Technical Service Bulletin: TSB190018	Released Date: 25-Mar-2019
Lubricating Oil Pumps with Unexpected Oil Pressures

Lubricating Oil Pumps with Unexpected Oil Pressures

Figure 1, Existing Lubricating Oil Pump with Pinned Regulator Plug.

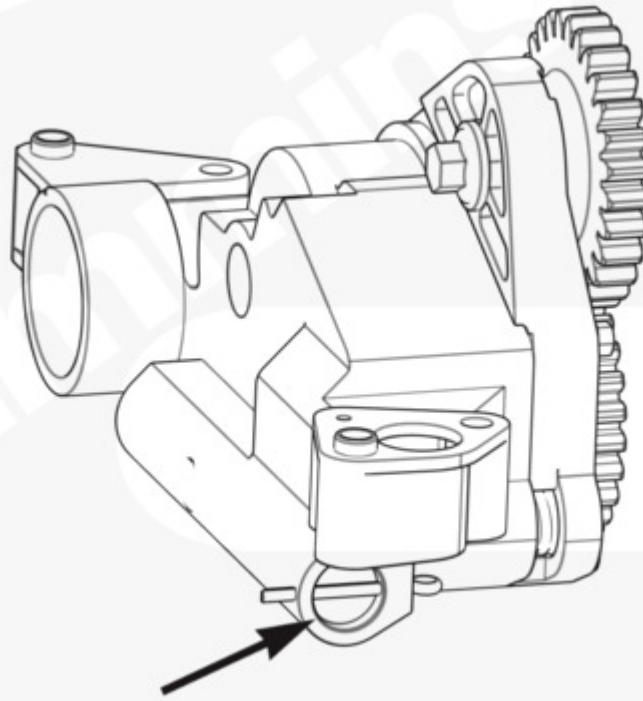
A new cast iron lubricating oil pump, Part Number 5532492, was released to replace an existing aluminum lubricating oil pump, Part Number 3687527, and cast iron lubricating oil pump Part Number 3687528, for some 15L engines. New Part Number 5532492 has different flow characteristics that do **not** affect lubricating oil system function, but can result in different oil pressure values than expected. Part Number 5532492 does **not** use shims to set gear lash like existing lubricating oil pump Part Numbers 3687528 and 3687527.

Lubricating oil pumps can be identified by the style of the regulator plug on the bottom of the lube pump. The new pump has a threaded plug. Existing pumps have a pinned plug. Pumps can also be distinguished by part numbers on the pump housings. See Figures 1 and 2 below.

New lubricating oil pump is backwards compatible, and interchangeable on engines using existing lubricating oil pumps. New pump does **not** use shims to set gear lash. For instructions on measuring and setting gear lash, see corresponding Service Manuals. Reference section 007-031.
